STAFF RECOMMENDATION
1521 Woodland Street
March 18, 2020

Application: New Construction—Infill and Outbuilding (DADU); Setback determination

District: Lockeland Springs-East End Neighborhood Conservation Zoning Overlay

Figure 1. Vacant lot at 1521 Woodland St.

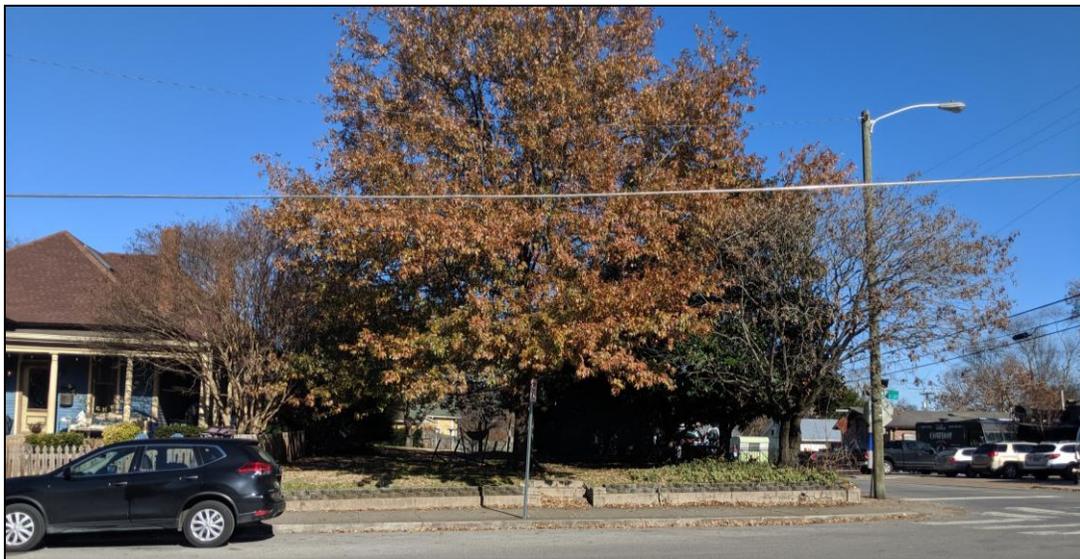
Background: The property located at 1521 Woodland Street is a vacant lot located at the northwest corner of North 16th Street and Woodland Street (Figure 1). At forty-seven feet, six inches (47'-7") wide, the lot is one of the narrower lots on this block of Woodland Street. The Commission disapproved a proposed two-story infill at this location in December 2019. The revised plan is for a one and one-half story design.
